Z-48
(2014)

ZONING PLAN FOR:
DAVID PEARSON COMMUNITIES
PROPERTY IS LOCATED IN LAND LOT 629 & 630
IN THE 18TH DISTRICT, 2ND SECTION
COBB COUNTY, GEORGIA
DATE: APRIL 21, 2014
SCALE: 1" = 50' REVISION: JULY 24, 2014

ZONING COMMENTS:

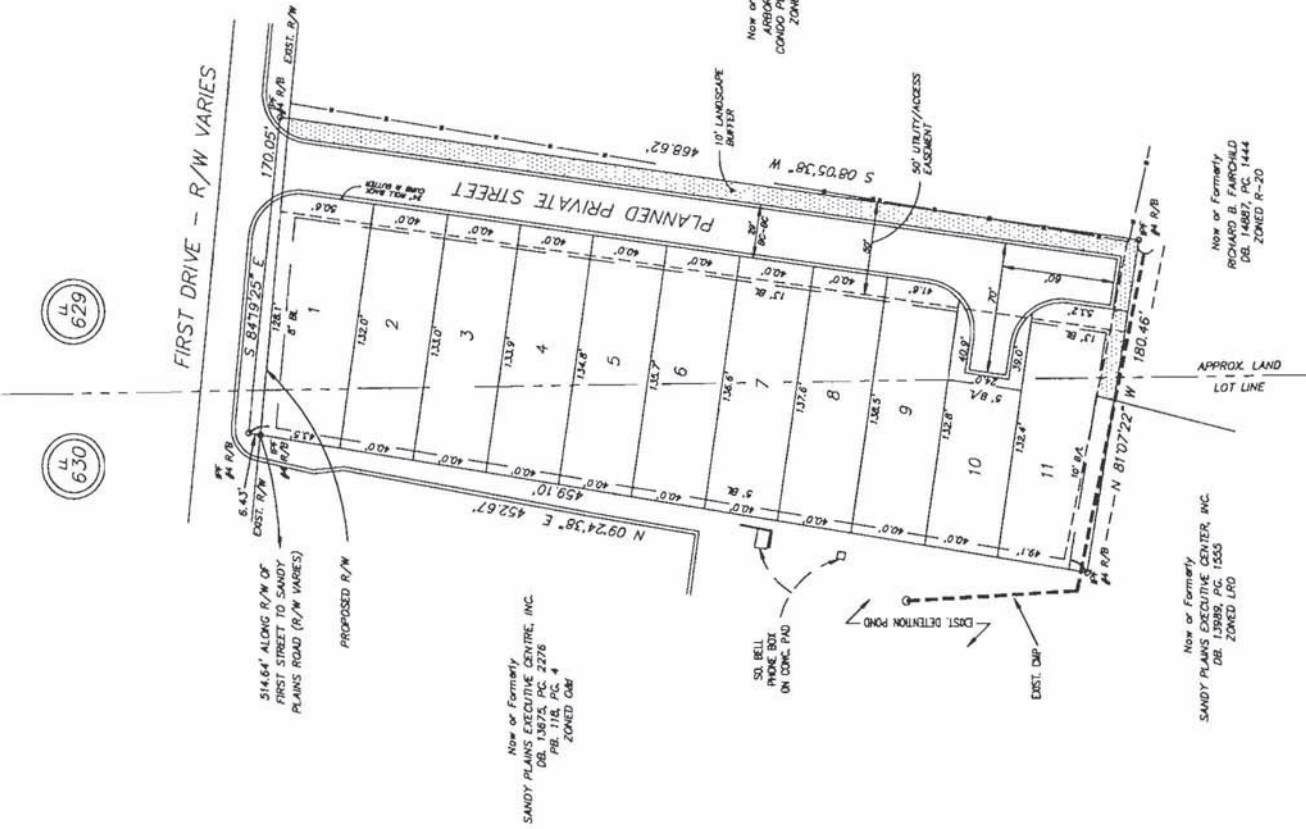
The site plan indicates a private street is planned and the applicant requests that the setbacks for the development be geared toward the private street, instead of First Drive. This will require granting a waiver of the front setback along the private street from 25 feet to 13 feet; waiving the rear setback abutting the eastern property line from 35 feet to 20 feet.

When projects contemplate less than 20 foot separation between units, guest parking shall be provided or the streets shall be labeled as a fire lane.

Additional Comments: Master meter to be set at public ROW

Additional Sewer to be private in private street
Comments:

- ☒ Potential or Known drainage problems exist for developments downstream from this site.
☒ Stormwater discharges must be controlled not to exceed the capacity available in the downstream storm drainage system.
☒ Minimize runoff into public roads.
☒ Minimize the effect of concentrated stormwater discharges onto adjacent properties.
☐ Developer must secure any R.O.W required to receive concentrated discharges where none exist naturally
☐ Existing Lake Downstream _____.
Additional BMP's for erosion sediment controls will be required.
☐ Lake Study needed to document sediment levels.
☒ Stormwater discharges through an established residential neighborhood downstream.
☒ Project engineer must evaluate the impact of increased volume of runoff generated by the proposed project on existing downstream Arbor Oaks drainage system and detention pond.

1. This site is located on First Drive between Sandy Plains Executive Center to the west and the Arbor Oaks Suburban Condominium development to the east. The entire site drains to the east through the Arbor Oaks development. With the proposed layout a drainage easement will be required along the rear of all the lots to adequately control runoff from the site. Since it appears that underground detention will be utilized under the private street, it may be necessary to relocate the street to the low-side of the site, adjacent to Arbor Oaks, to adequately control site runoff.

2. The detention pond for the adjacent Sandy Plains Executive Center discharges through an existing pipe along the southern boundary of this site. An adequate drainage easement must be provided for this conveyance.

3. Since private streets are proposed all stormwater management within the development including the detention facility will be privately maintained in perpetuity by the HOA.

First Drive is classified as a local and according to the available information the existing right-of-way does not meet the minimum requirements for this classification.

Recommend applicant consider entering into a development agreement pursuant to O.C.G.A. 36-71-13 for dedication of the following system improvements to mitigate traffic concerns: a) donation of right-of-way on the south side of First Drive, a minimum of 25' from the roadway centerline.

Recommend curb, gutter, and sidewalk along the First Drive frontage.

Recommend a deceleration lane and left turn lane for the Paul Samuel Road access.

Recommend private streets be constructed to the Cobb County Standard Specifications.

Based on the above analysis, Staff recommends DELETING the request to RA-5 subject to the following conditions:

- Site plan to meet all RA-5 requirements;
- Detached, single-family houses only;
- Fire Department comments and recommendations;
- Water and Sewer Division comments and recommendations;
- Stormwater Management Division comments and recommendations;
- Department of Transportation comments and recommendations; and
- Owner/developer to enter into a Development Agreement pursuant to O.C.G.A. §36-71-13 for dedication of system improvements to mitigate traffic concerns.
